HUNTERS RIDGE BUILDING H

Pasco County Florida
REVIEWED FOR CODE COMPLIANCE
Approval of these documents constitutes
authority to proceed with the work but does not
grant authority to violate, cancel, alter or set
aside any of the technical codes

COVER SHEET BUILDING H

HUNTERS RIDGE
 NEW PORT RICHEY

SLAB PLAN BUILDING H

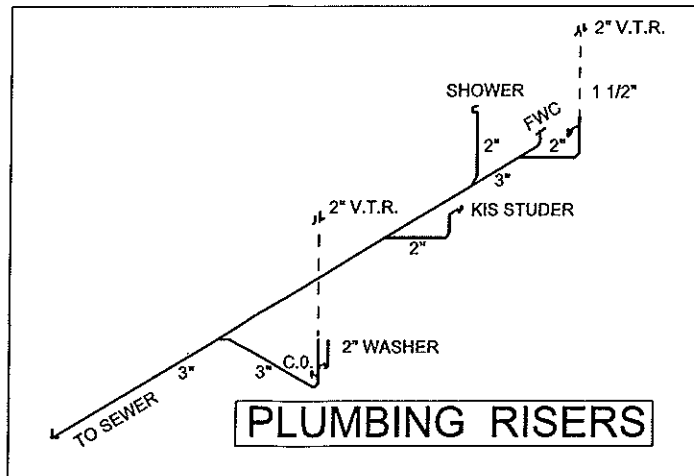
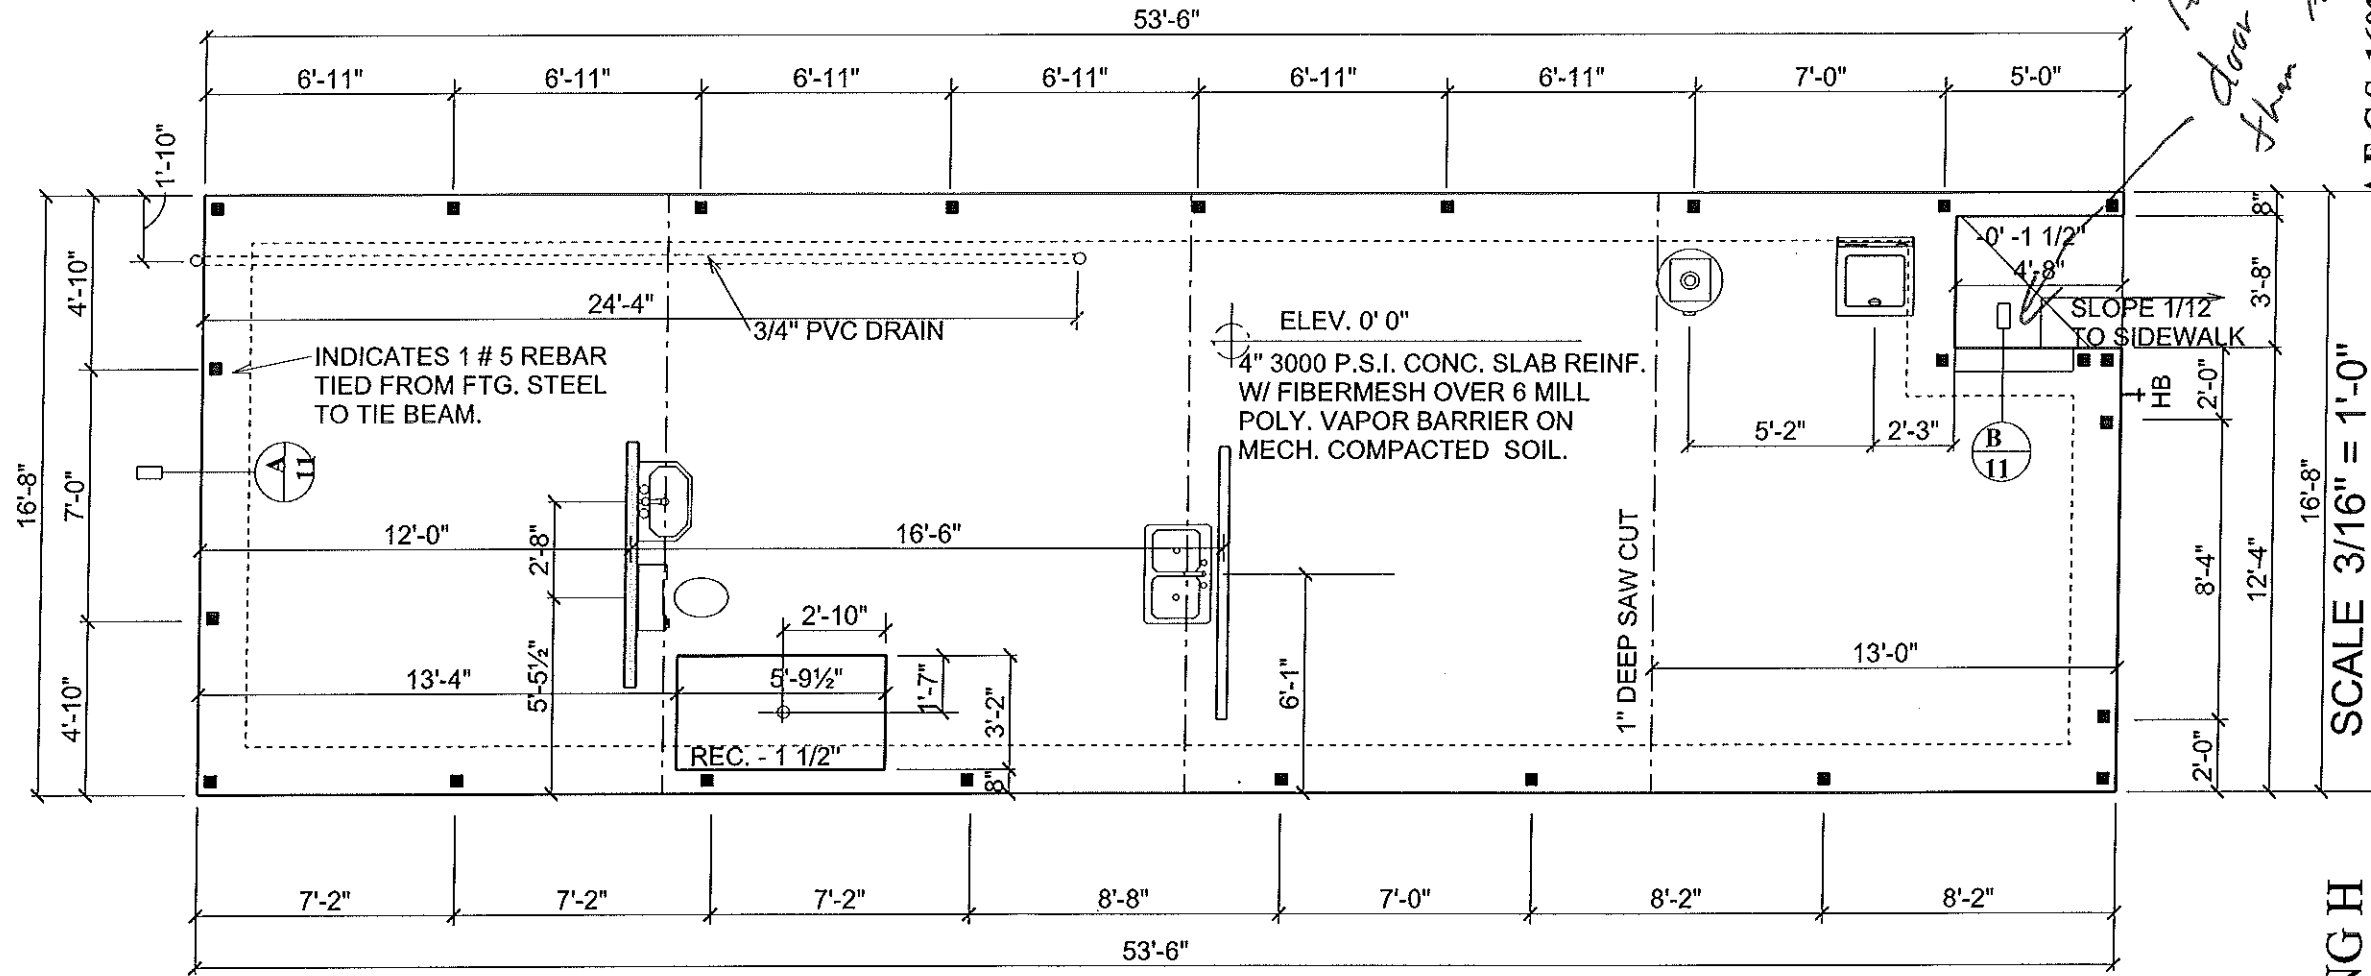
*FHAG
lever change so the
door must be 1/2" from*

8" THICKENED SLAB (J)

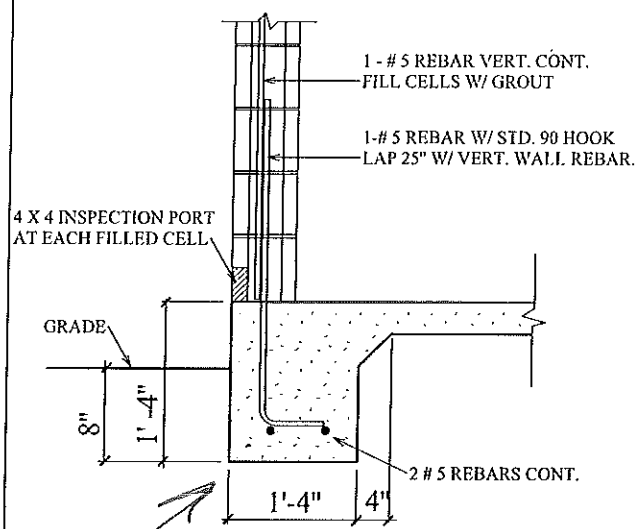
Geotechnical Report Recommends 18" wide footer
